PLANNING COMMISSION

**Planning Commission Agenda
Regular Meeting
Virtual Meeting via GoToMeeting*
Thursday, December 10, 2020
6:00 P.M.**

- b. **P2020-026: Lupton Village Change of Zone**
- c. **P2020-027: Lupton Village Preliminary Plat & Preliminary PUD Plan**

SHEET
C9.0

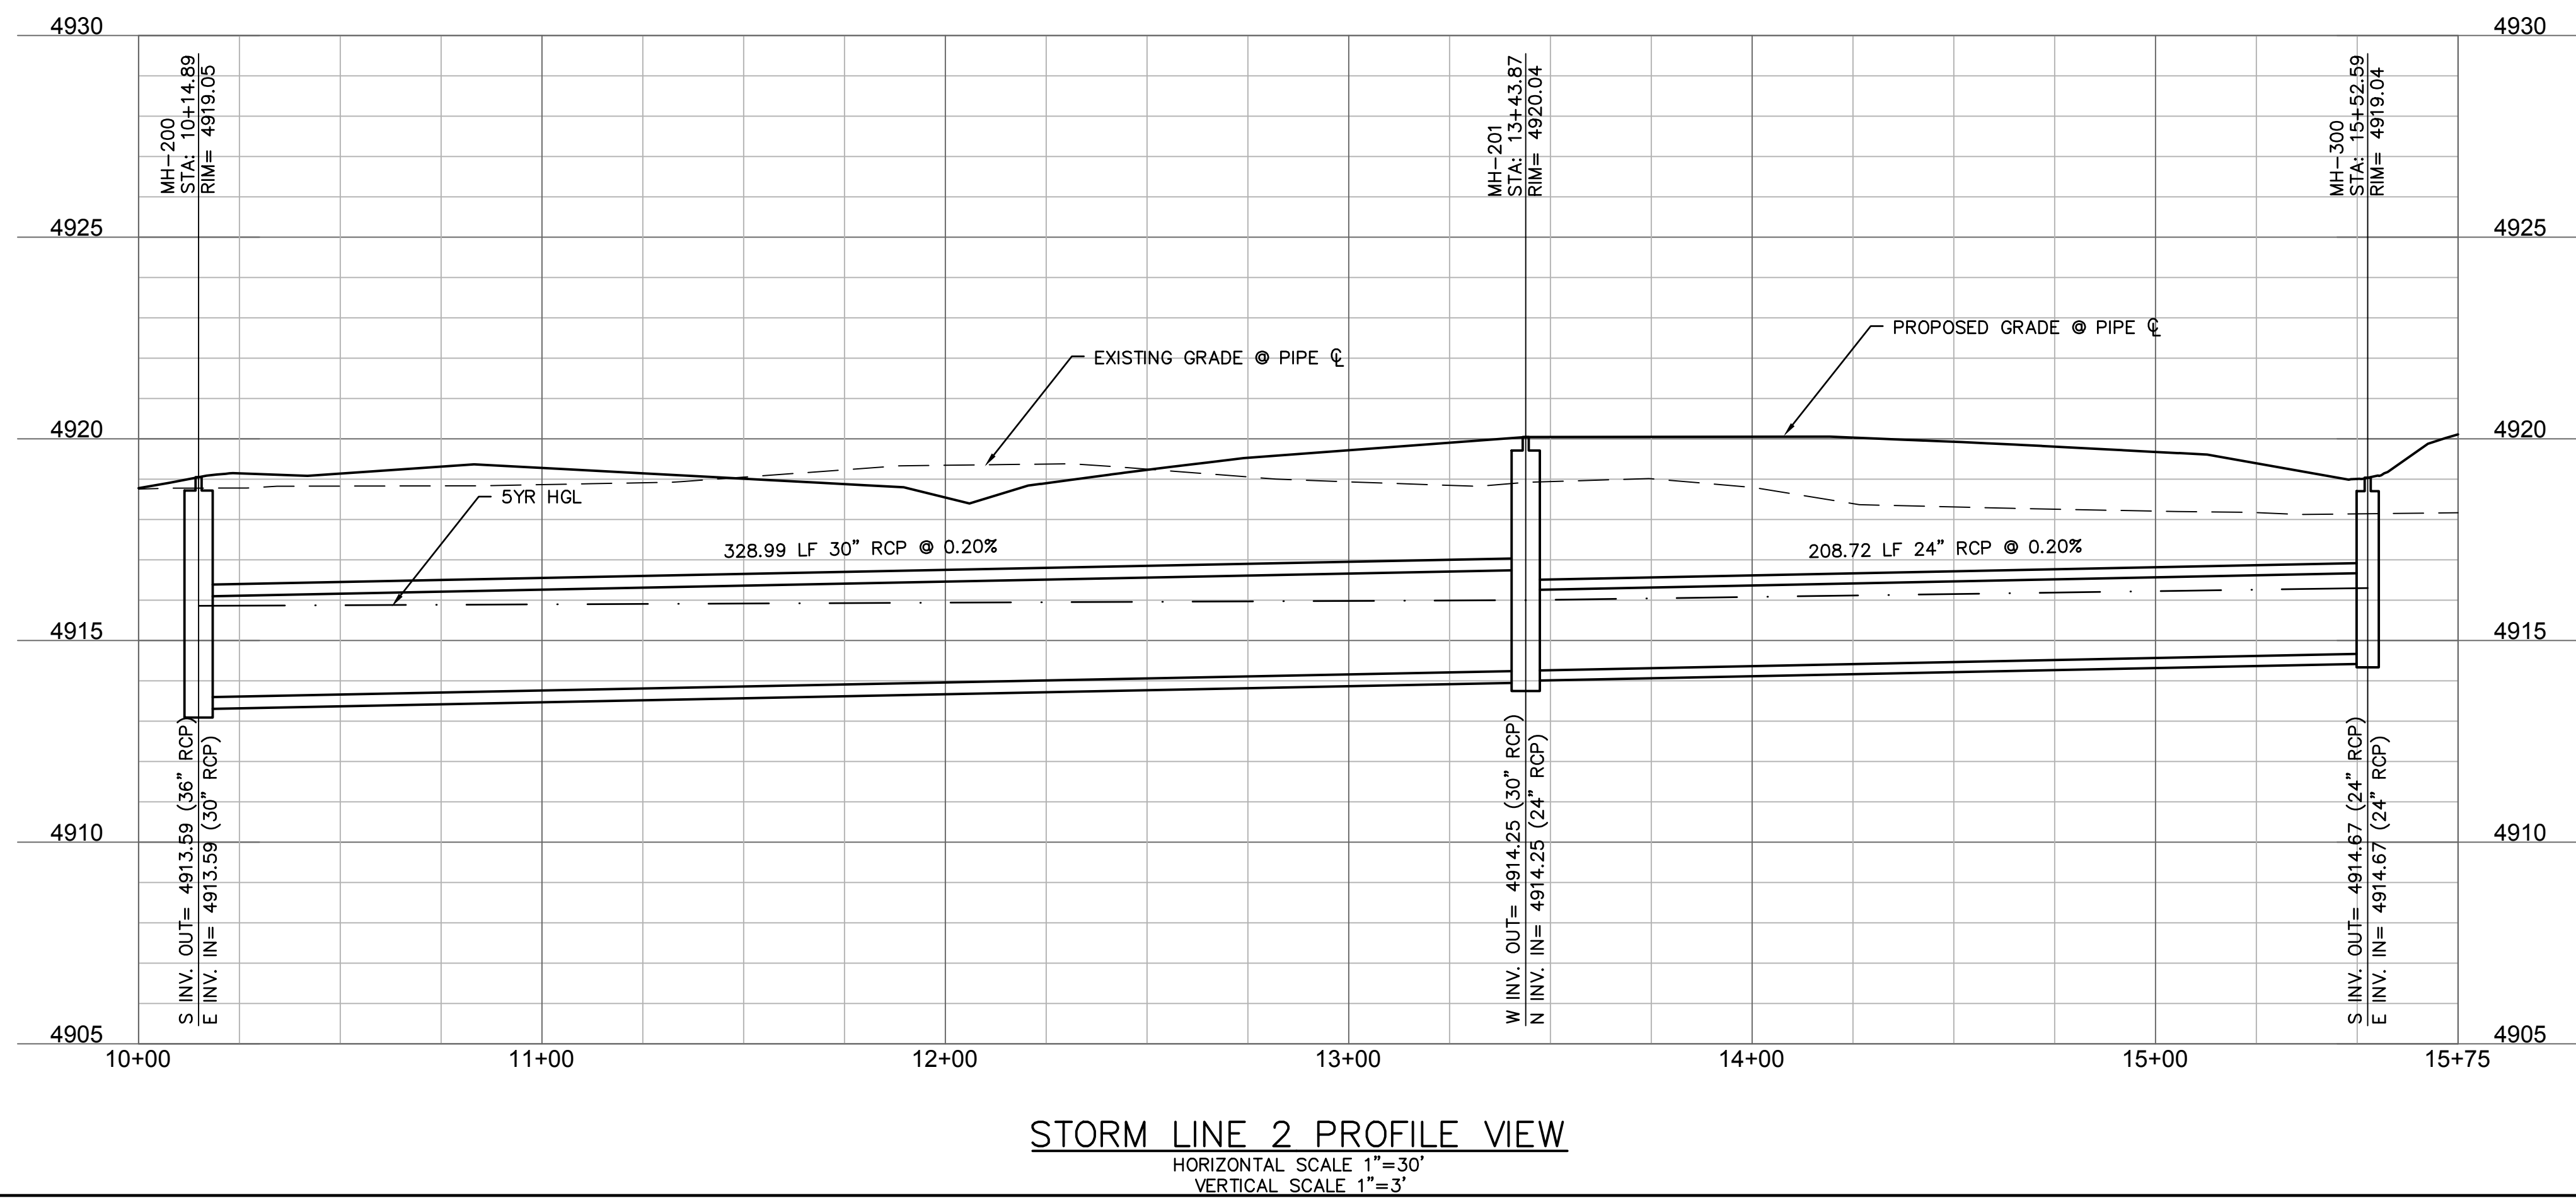
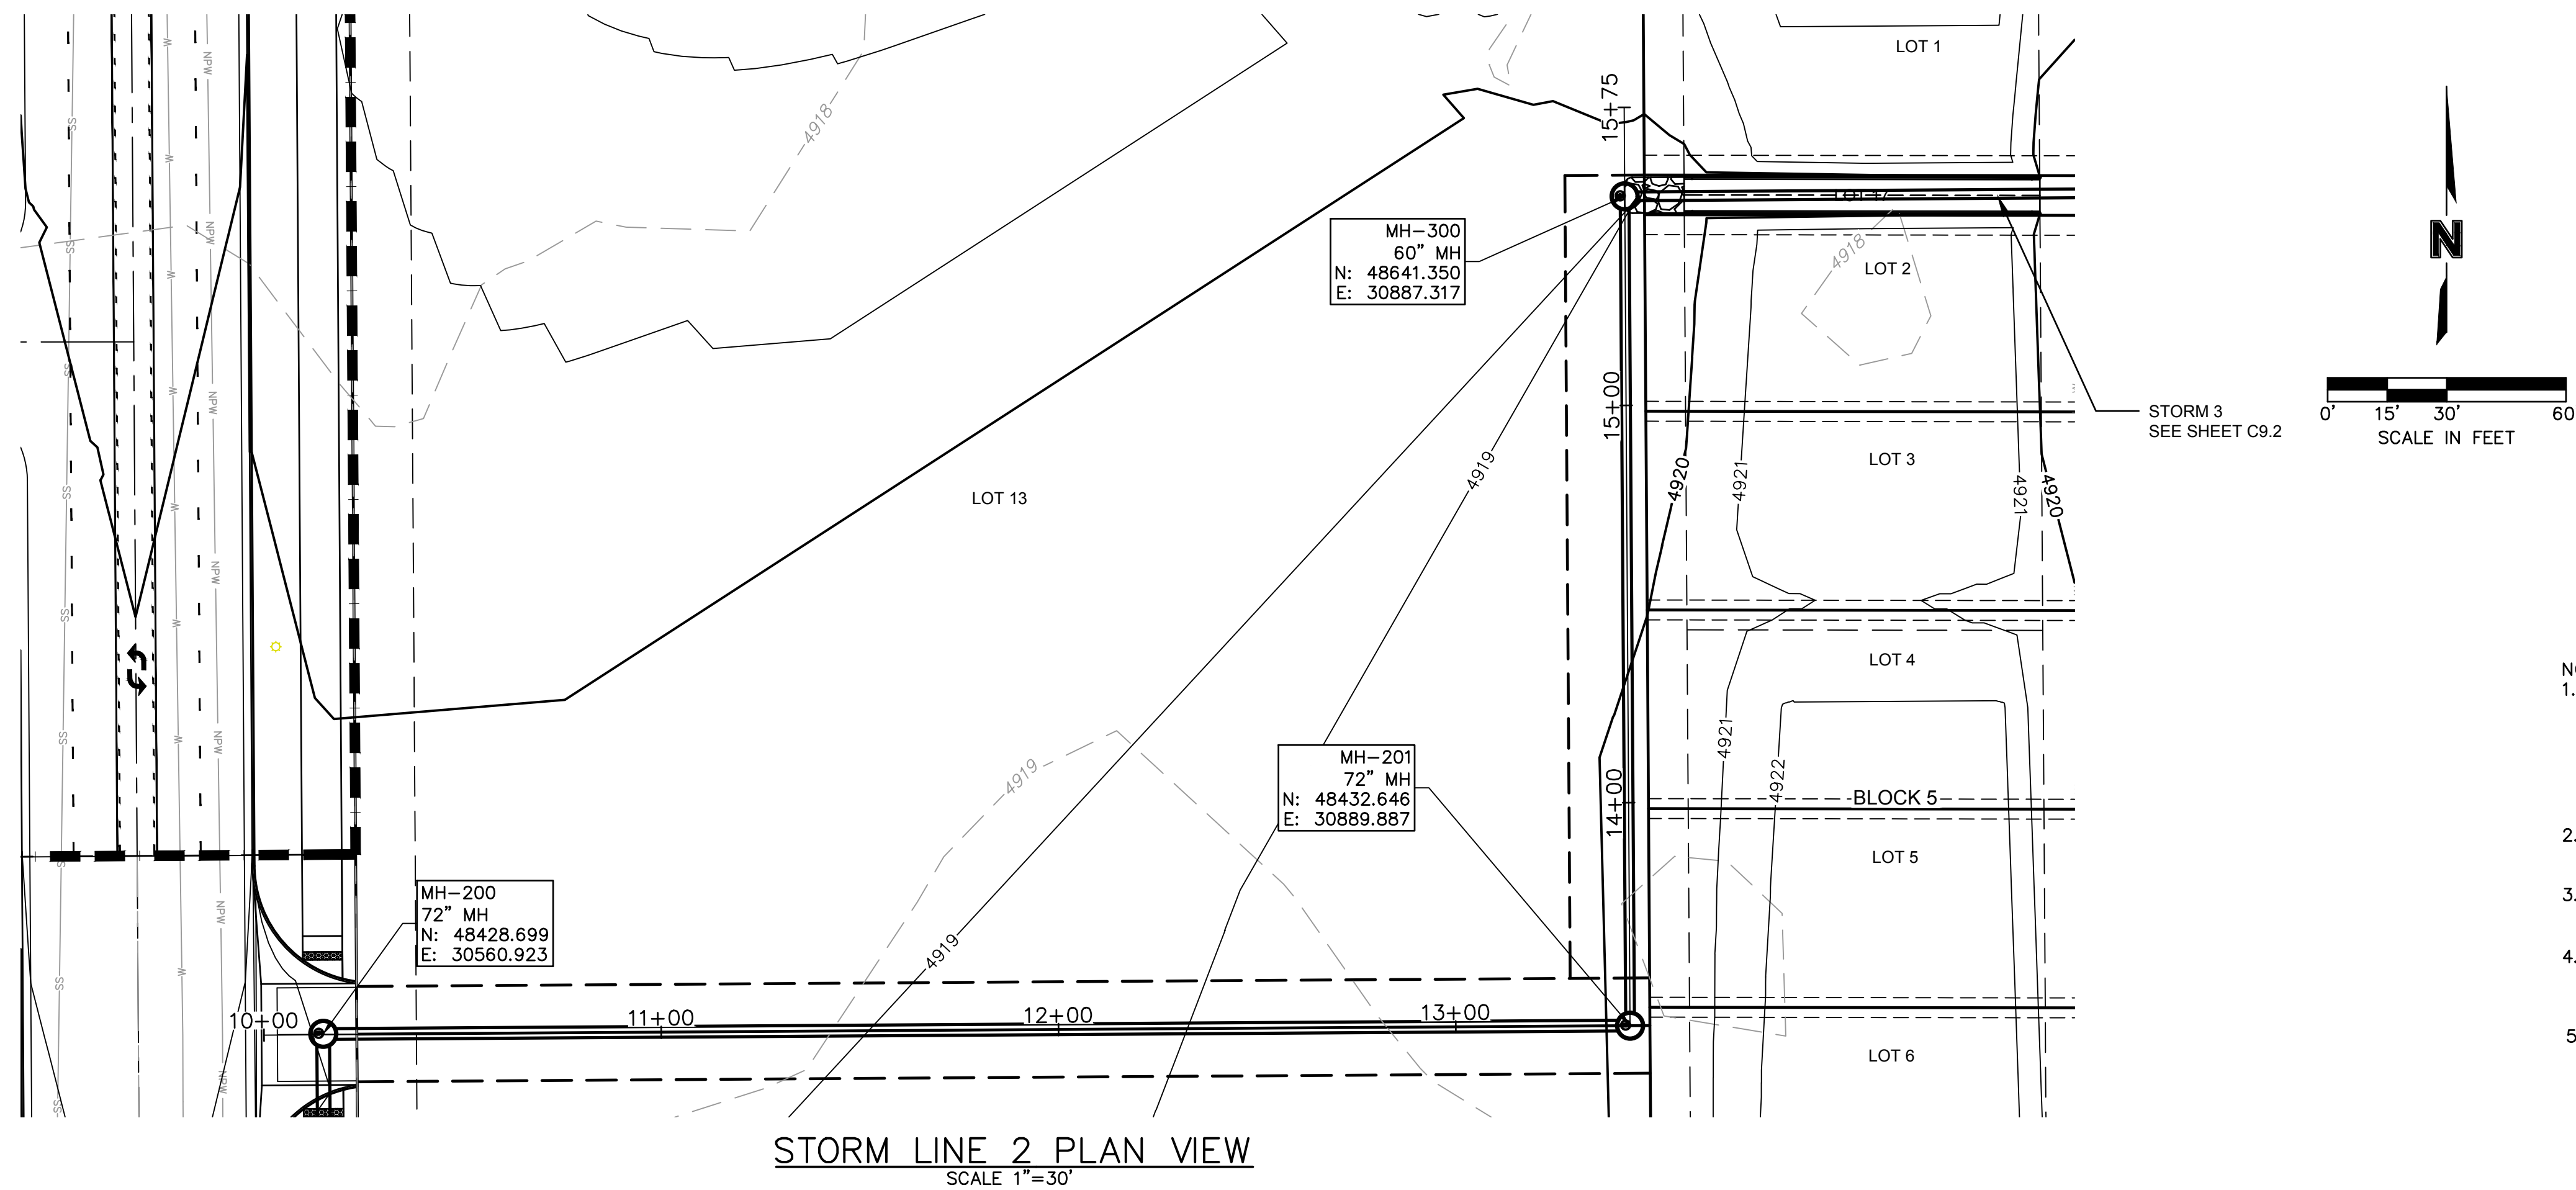
- ii. Sheet C9.0 - Can the storm outfall be adjusted into the overflow swale and discharge into the swale?
- iii. Sheet C9.0 - 9.3 - Hydraulically, matching crown of pipes is better
